Waiver Request to Stormwater Management Criteria, Re: Sprengergarton, LLC (19WV00003) (District 3)

Staff Report

Permit # 18RW00621 Sprengergarten

Subject: Trench Drain Waiver Request

Figure 1: Conceptual Plan - Aerial View

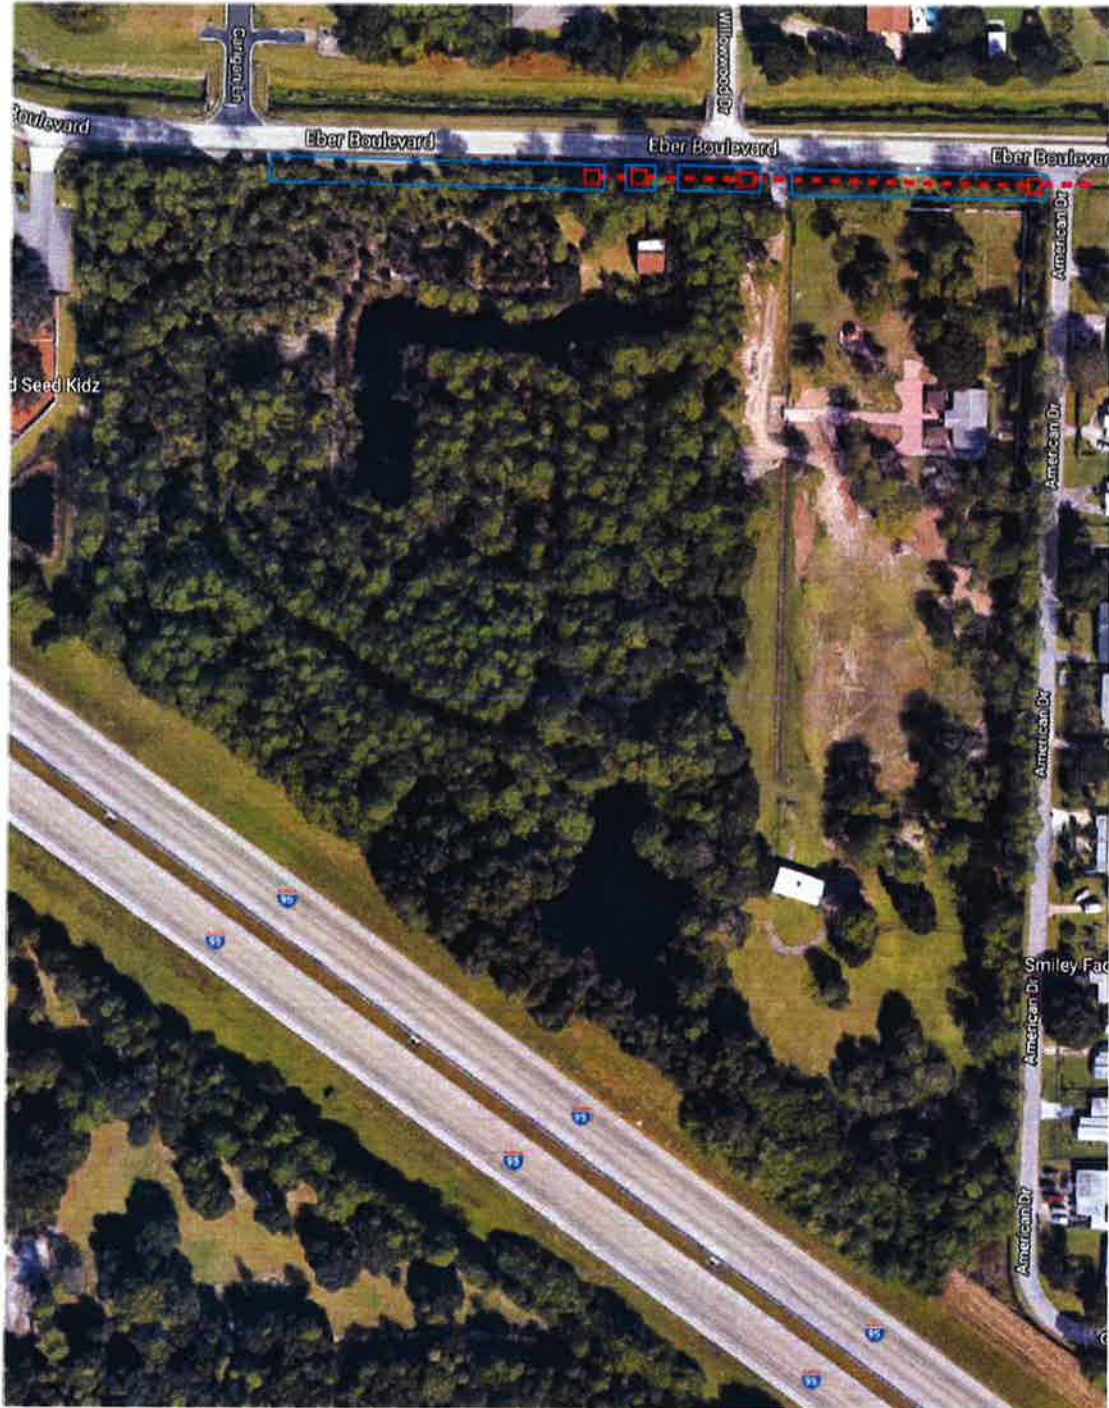
One alternative design consists of piping in the right-of-way connecting to the pipe under American Drive. The pipe would be installed low enough preventing humps or steep grades within the driveways. Above the piped system, a shallow retention area would be constructed to flow into ditch bottom inlets that would serve as control structures to meet retention volume requirements. Power poles would be relocated to the ROW line to remove them from the flow line. This can be easily accommodated as the utility lines are installed vertically with no overhang. Inlet locations and pipe alignment would be adjusted as necessary to avoid utility boxes. Refer to Figure 1 and Figure 2 below for conceptual plan information.

Figure 4: Existing Conditions – 2825 Eber Blvd Property Frontage, Looking West

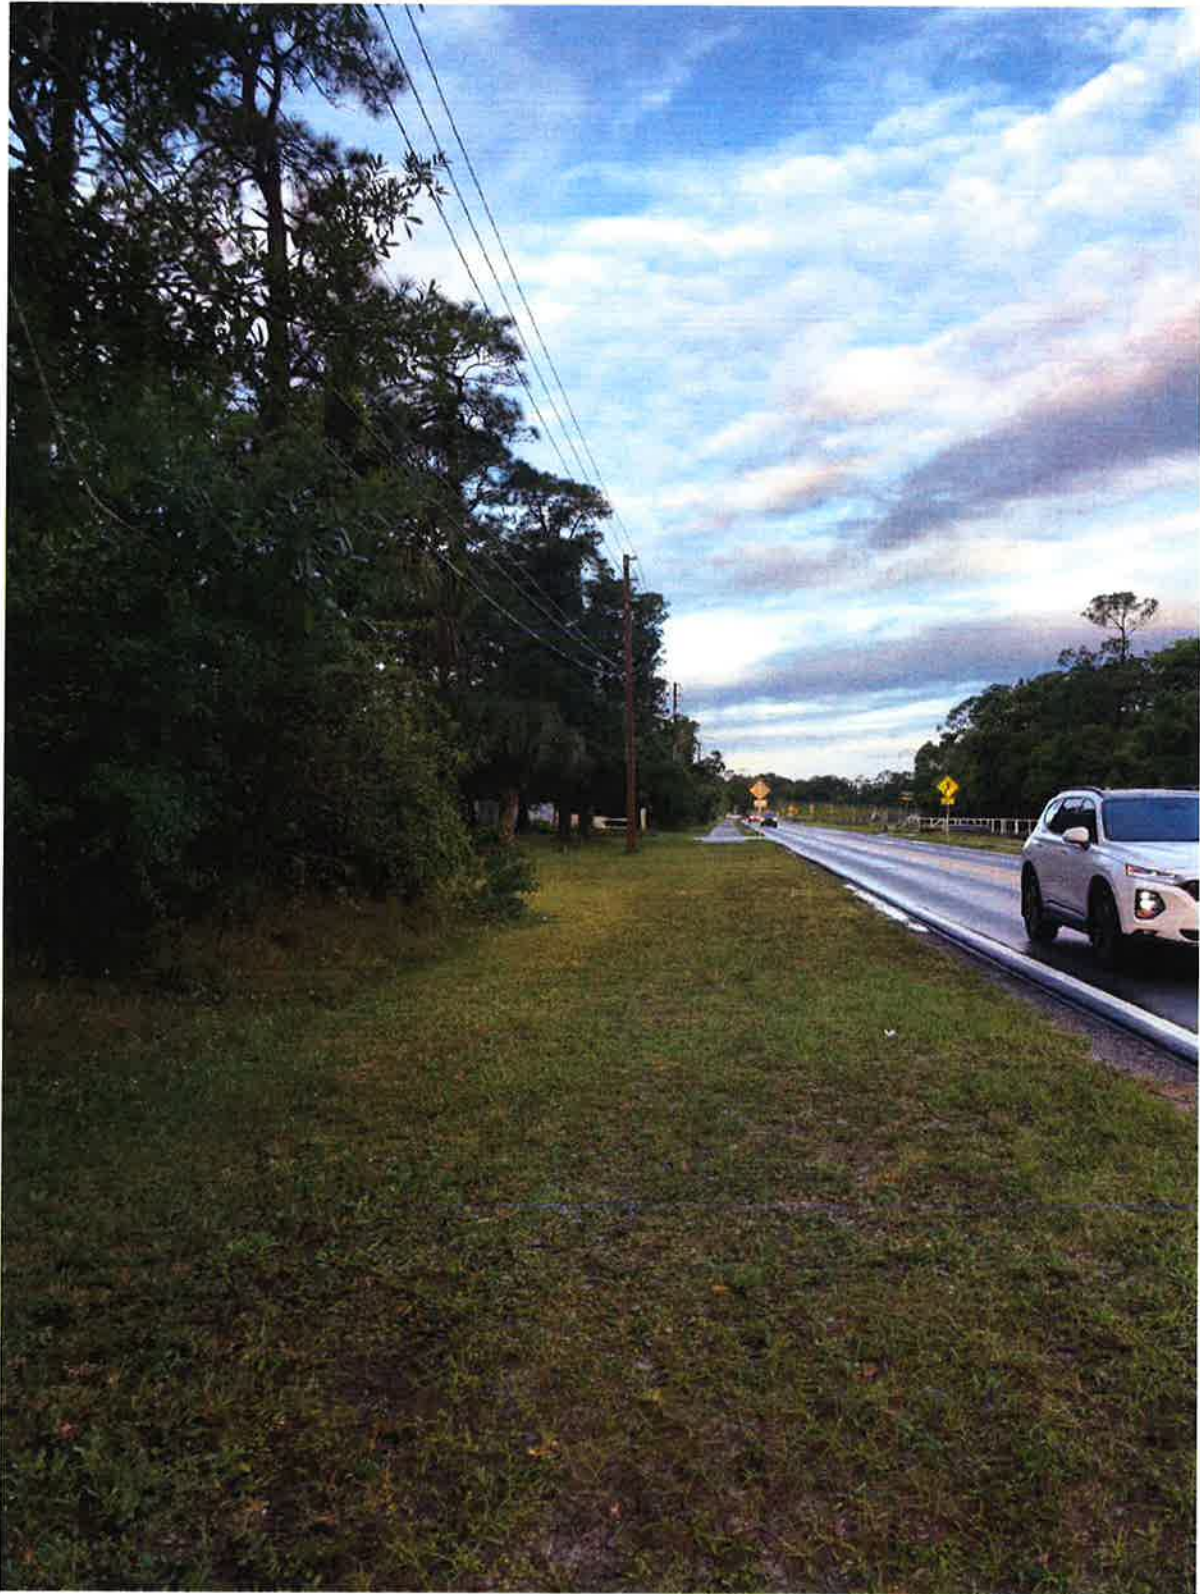
These are just a few other design options that satisfactorily meet County requirements. Also attached are site visit photos showing existing conditions within the Eber Blvd right-of-way.
